Technical Bulletin

Subject: Revised Front Wheel Hubs and Tension Ring

Number
9405

Figure A

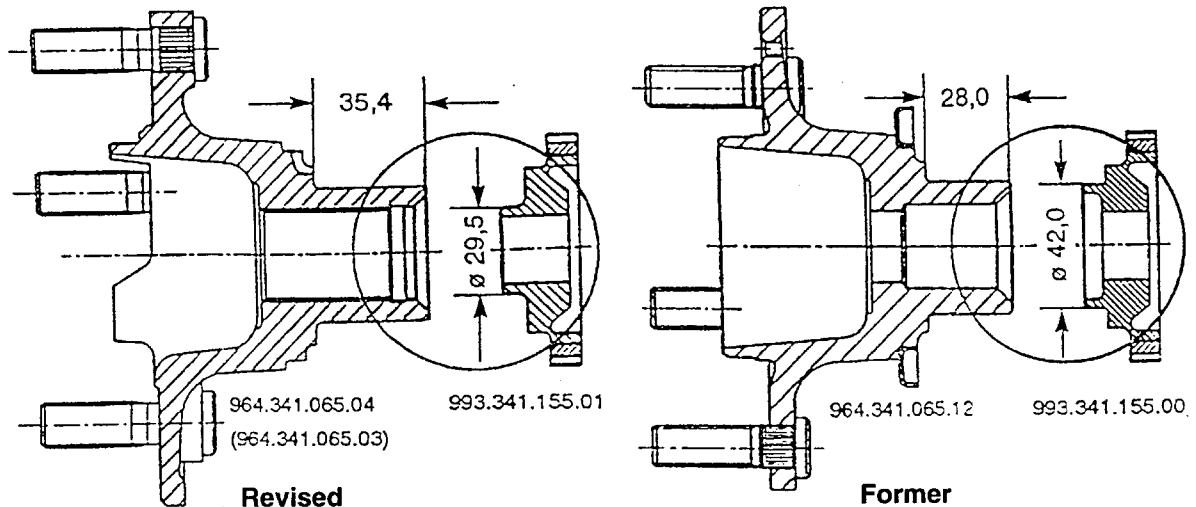
The revised wheel hubs and tension rings are changed in the wheel bearing area (see Figure A, circle). The tension ring is now being centered by the wheel hub and no longer by the bearing ring.

If on cars produced before March 7, 1994 introduction date, the wheel hub or the tension ring is being replaced, the correct application of hub and tension ring must be adhered to. See chart below:

NOTE: No other selection is permissible!
